CITY OF SAINT PAUL
HERITAGE PRESERVATION COMMISSION STAFF REPORT

FILE NAME: 720 Seventh Street East – The Cambric Senior Apartments
DATE OF APPLICATION:
APPLICANT: Cedar Creek Energy
ARCHITECT: Gary Vogel, BKV Group, Inc.
OWNER: Dominium Development – Patrick Ostrom
DATE OF HEARING: July 28, 2016
HPC SITE/DISTRICT: Dayton's Bluff Heritage Preservation District
CATEGORY: New Construction
CLASSIFICATION: Building Permit
STAFF INVESTIGATION AND REPORT: Allison Suhan
DATE: July 19, 2016

B. PROPOSED CHANGES:

Solar Panel Layout

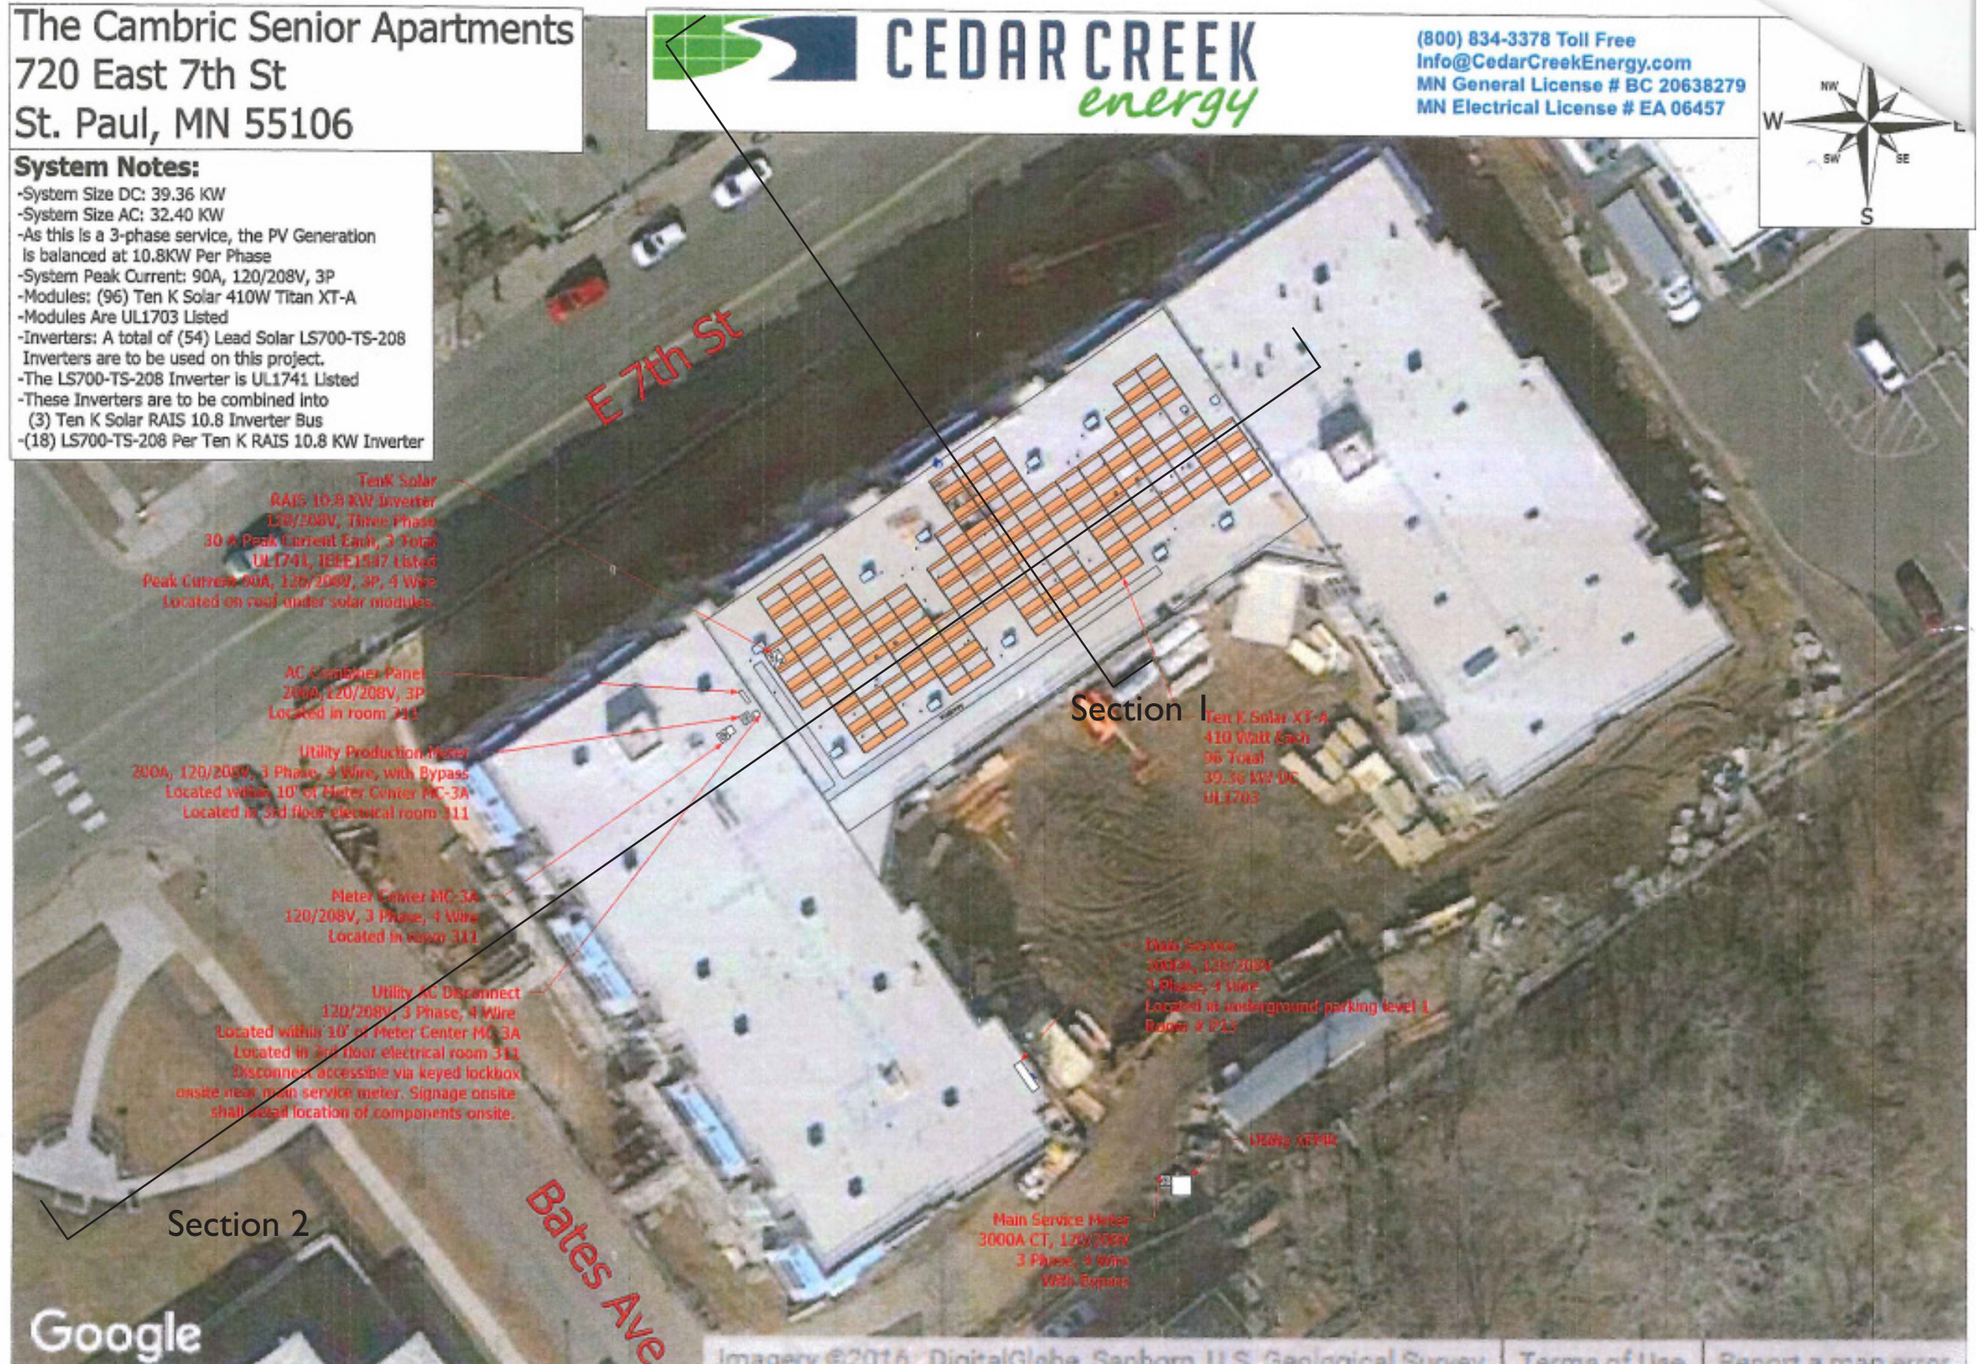
4. **74.90(g)(2)a Roofs.** The building has a flat roof with a mansard roof-like detail at the top floor on the primary elevations and turning the corner to the secondary elevations; which serves to reduce the visual massing of the building. The building has a 2' tall parapet. *Roof hardware such as skylights, vents and metal pipe chimneys should not be placed on the visible portion of the roof* and should be setback from the roof edge so as not to be visible. The proposed solar array will be set back 36" from the northwest roof line and 13'8" from the

southwest roof line. The setback from the southwest roof line is appropriate; however, the northwest roof line set back is not appropriate given the 29" height of the solar panels.

1. The solar array shall be set back at least 5 feet from the northwest roof line.
2. All final materials, colors and details shall be submitted to the HPC and/or staff for final review and approval.
3. Any revisions to the approved plans shall be reviewed and approved by the HPC and/or staff.
4. A copy of the HPC stamped approved plans shall remain on site for the duration of the construction project.

View Study - Section1

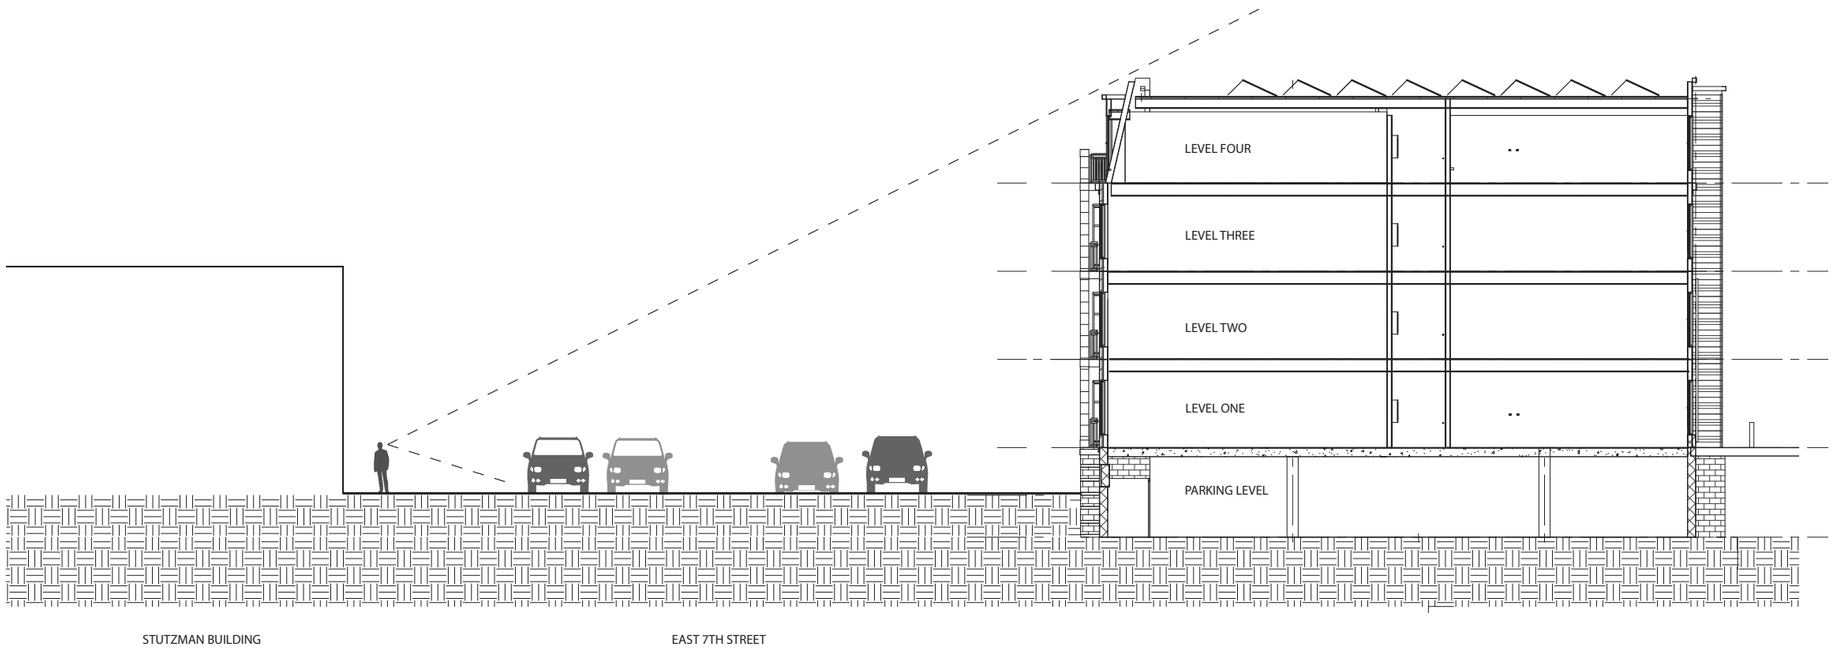
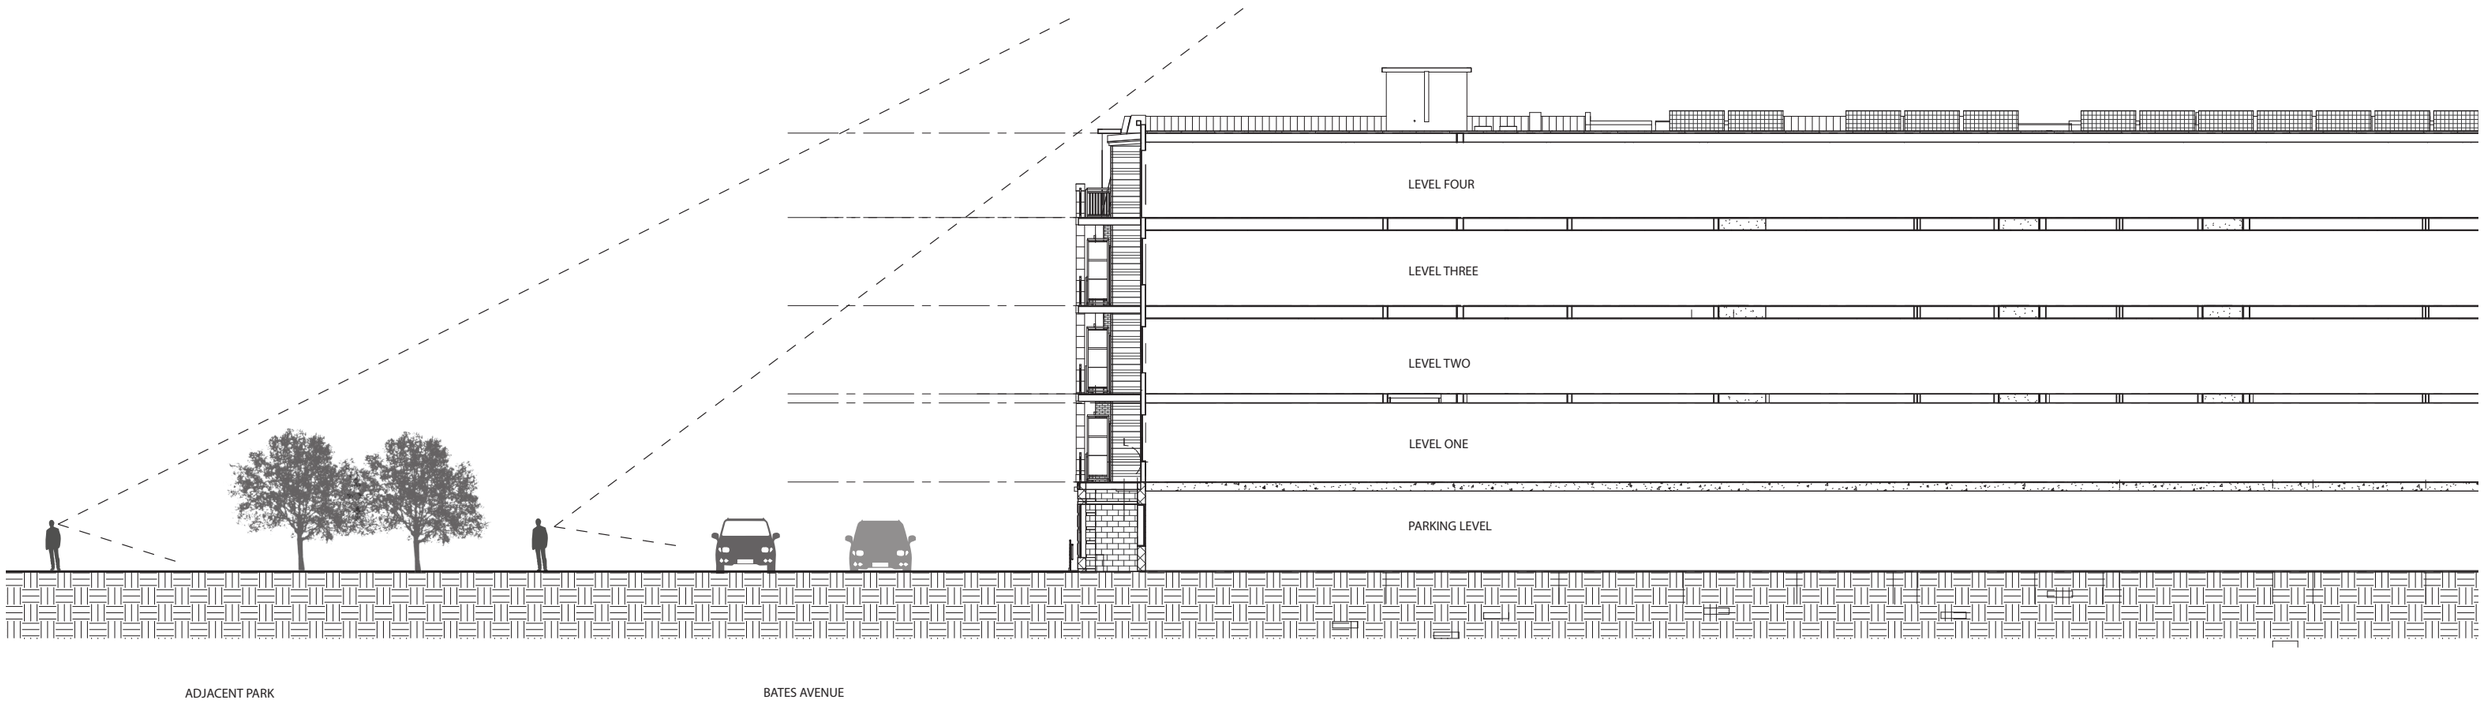
3. **74.90(b)(4)** ***Views and vistas.*** *Exceptional views of the city and river valley provided from the public way should not be obstructed by new buildings or structures.* The view studies provided show that the solar array will not be visible from the public right of way from the northwest or southwest. However, view studies from the east, which are elevated from the property, were not provided.
